## Landscape Referral Response

<b>Application Number:</b>	Mod2021/0793
<b>Date:</b>	04/11/2021
<b>Responsible Officer:</b>	Lashta Haidari
<b>Land to be developed (Address):</b>	Lot 101 DP 1209504 , 5 Skyline Place FRENCHS FOREST NSW 2086

Fig. 1 Mod Architectural Plans with terrace to Skyline PI. Fig 2. Mod Landscape Plan with terrace to Skyline PI.

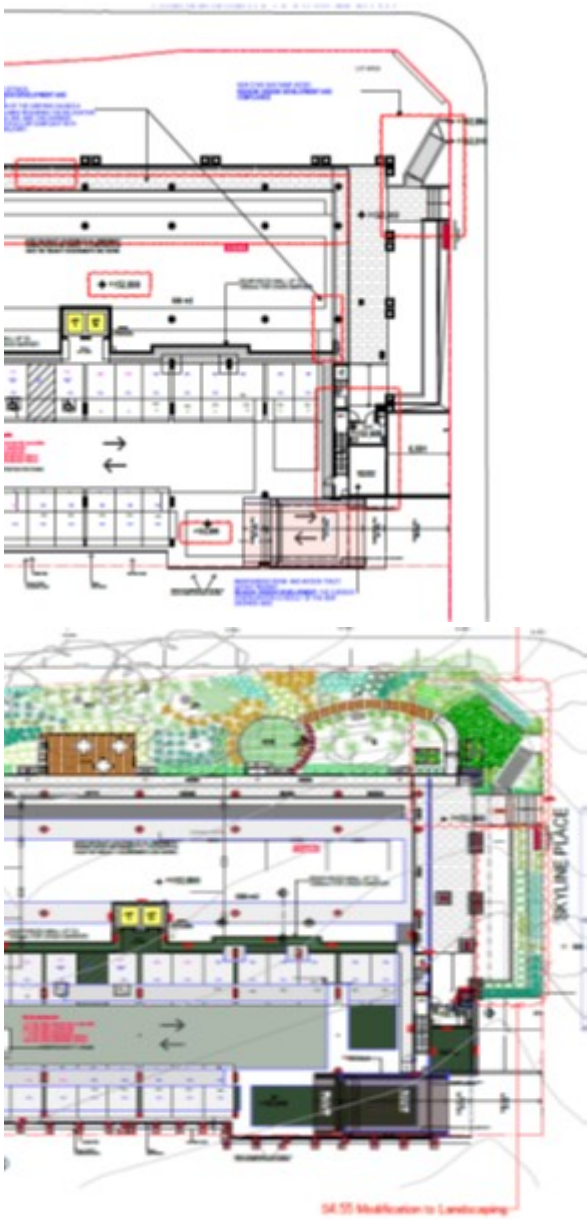
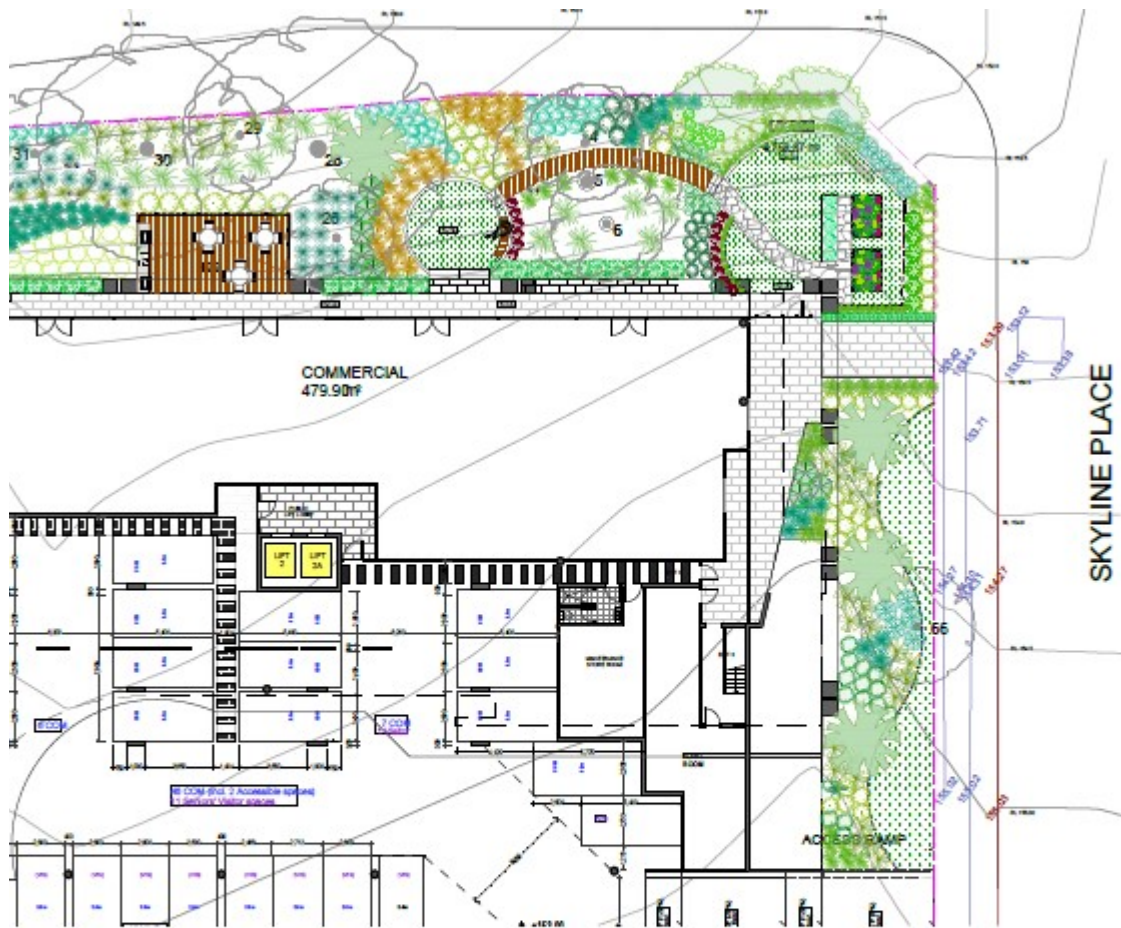
The Landscape Plans indicate reduction of approved soft landscaping in the setback to Skyline Pl. replaced with what appears to be an extended terrace adjacent to the commercial component (Figs. 1 and 2 below). Whilst the plans indicate terraced planters on the boundary, it is considered that the loss of approved deep soil planting in this setback area (Fig. 3) reduces the opportunity for softening of the built form, and reduction in provision of canopy trees commensurate with the bulk and scale of the building and the existing streetscape.

It is noted that the Architectural Plans do not indicate the need for the extended terrace, though other modifications are clearly annotated.

Fig. 5 Mod Plan indicating increased parking and deletion of approved landscaping.

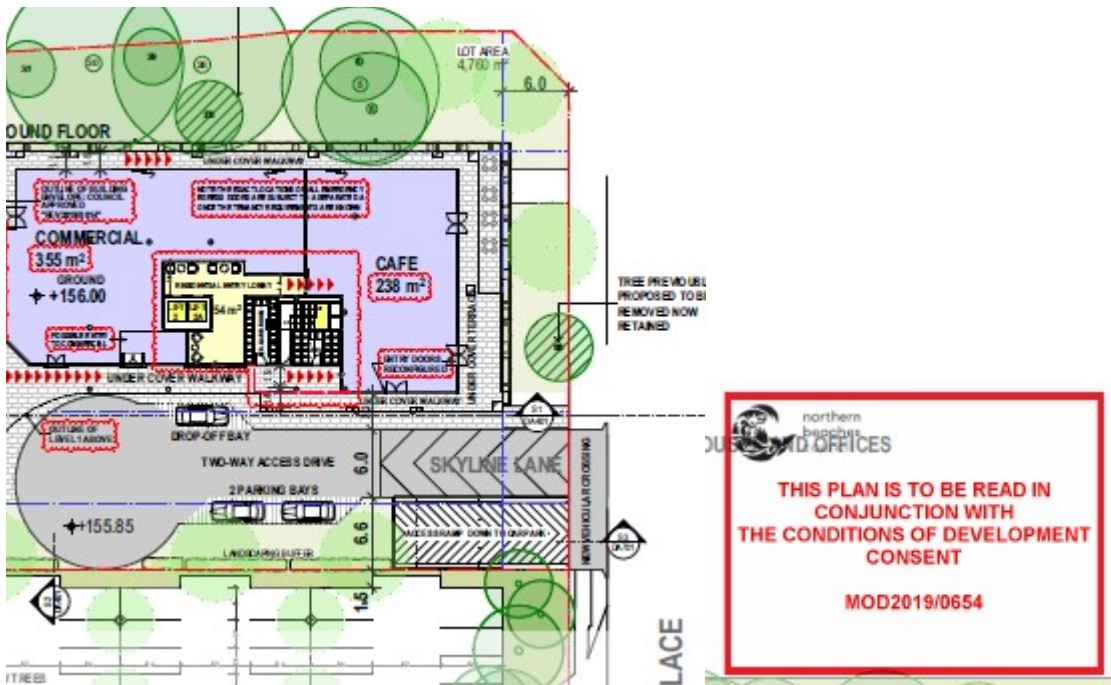
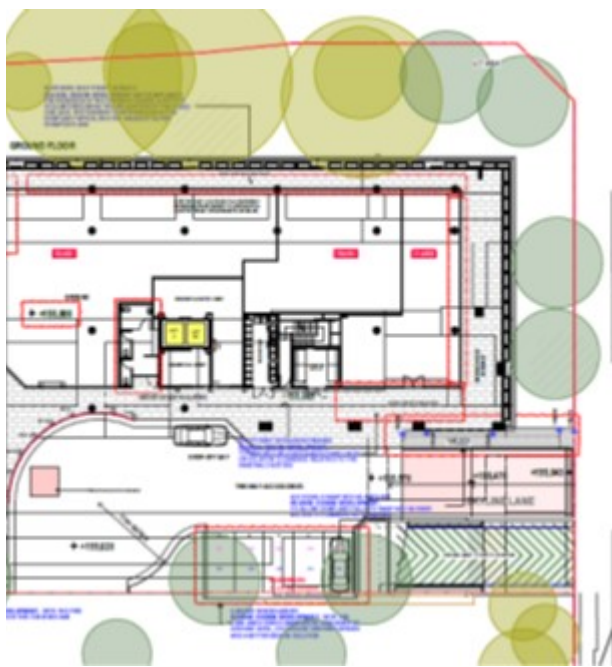
The plans indicate increase of parking bays at the rear of the site to service the commercial component (Fig 5). Provision of these bays deletes previously approved soft landscaping indicated on the approved and 'landscape buffer', providing relief between the sites and the approved carpark on the adjoining site. (Fig. 4)

The proposed modifications as described above are not supported with regard to landscape issues as the built form and hard components are extended at the cost of approved soft landscape works that were considered important in maintaining existing and desired character and providing softening of the significant built form.
